ECE/TRANS/WP.29/GRE/2007/14
28 December 2006

REGULATION No. 37
(Filament lamps)

Provisions for new filament lamp categories

Proposal for draft Supplement 29 to the 03 series of amendments to Regulation No. 37

Sheet H6W/1

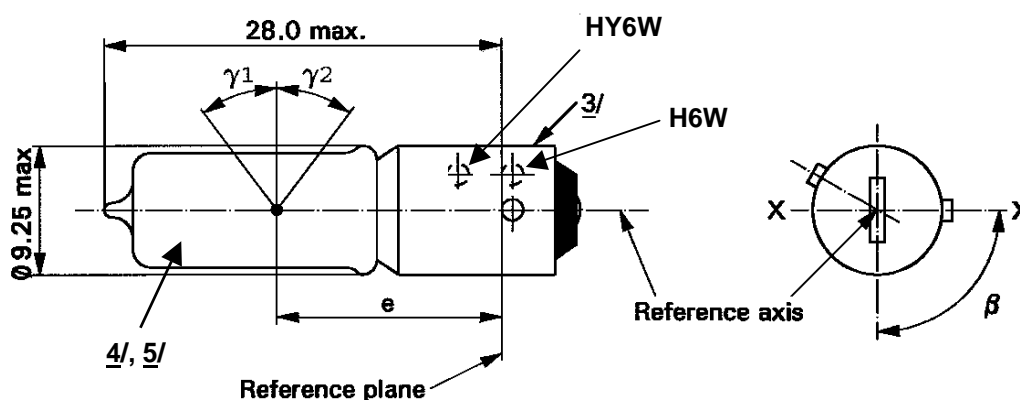
Sheets H6W/1 and H21W/1, amend to read (see next pages):

Dimensions in mm		Filament lamps of normal production			Standard filament lamp
		min.	nom.	max.	
e		14.25	15.0	15.75	15.0 ± 0.25
Lateral deviation	<u>1/</u>			0.75	0.4 max
α		82.5°	90°	97.5°	90° ± 5°
γ_1, γ_2	<u>2/</u>	30°			30° min.
Cap:	H6W: BAX9s HY6W: BAZ9s	in accordance with IEC Publication 60061 (sheet 7004-8-1) in accordance with IEC Publication 60061 (sheet 7004-150-1)			
ELECTRICAL AND PHOTOMETRIC CHARACTERISTICS					
Rated values	Volts	12			12
	Watts	6			6
Test voltage	Volts	13.5			13.5
Objective values	Watts	7.35 max.			7.35 max.
	Luminous flux	H6W	125 ± 12 %		
		HY6W	75 ± 17 %		
Reference luminous flux at approximately 13.5 V					White:125 lm Amber:75 lm

- 1/ Maximum lateral deviation of filament centre from two mutually perpendicular planes both containing the reference axis and one containing axis X-X.
- 2/ In the area between the outer legs of the angles γ_1 and γ_2 , the bulb shall have no optically distorting areas and the curvature of the bulb shall have a radius not less than 50 per cent of the actual bulb diameter.
- 3/ Over the entire length of the cap there shall be no projections or soldering exceeding the permissible maximum diameter of the cap.
- 4/ The light emitted from filament lamps of normal production shall be white for category H6W and amber for category HY6W.
- 5/ The light emitted from standard filament lamps shall be white for category H6W and amber or white for category HY6W.

Sheet H21W/1

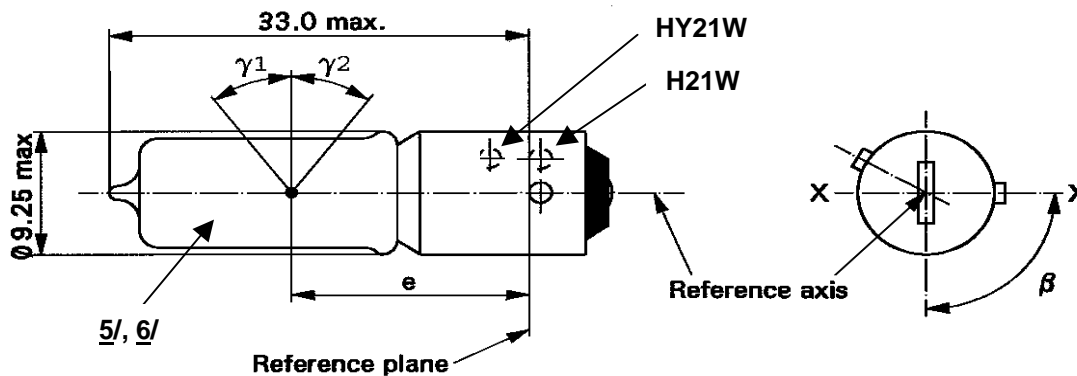
Dimensions in mm		Filament lamps of normal production			Standard filament lamp
		min.	nom.	max.	
e			20.0 <u>1/</u>		20.0 ± 0.25
f	12 V			3.8	3.8 + 0/ - 1
	24 V			4.5	
Lateral deviation <u>2/</u>				<u>1/</u>	0.0 ± 0.15 <u>3/</u>
β		82.5°	90°	97.5°	90° ± 5°
γ1, γ2 <u>4/</u>		45°			45° min.
Cap:	H21W: BAY9s HY21W: BAW9s	in accordance with IEC Publication 60061 (sheet 7004-9-1) in accordance with IEC Publication 60061 (sheet 7004-149-1)			
ELECTRICAL AND PHOTOMETRIC CHARACTERISTICS					
Rated values	Volts	12	24	12	
	Watts	21	21	21	
Test voltage	Volts	13.5	28.0	13.5	
Objective values	Watts	26.25 max.	29.4 max.	26.25 max.	
	Luminous flux	H21W	600 ± 12 %	600 ± 15 %	
		HY21W	300 ± 17 %	300 ± 20 %	
Reference luminous flux at approximately		12 V		White: 415 lm	
		13.2 V		White: 560 lm	
		13.5 V		White: 600 lm Amber: 300 lm

- 1/ To be checked by means of a "Box system", sheet H21W/2.
- 2/ Maximum lateral deviation of filament centre from two mutually perpendicular planes both containing the reference axis and one containing axis X-X.
- 3/ The lateral deviation with respect to the plane perpendicular to axis X-X is measured in the position described in paragraph 1. of the test procedure specified on sheet H21W/2.
- 4/ In the area between the outer legs of the angles γ1 and γ2, the bulb shall have no optical distorting areas and the curvature of the bulb shall have a radius not less than 50 per cent of the actual bulb diameter.
- 5/ The light emitted from filament lamps of normal production shall be white for category H21W and amber for category HY21W.
- 6/ The light emitted from standard filament lamps shall be white for category H21W and amber or white for category HY21W."
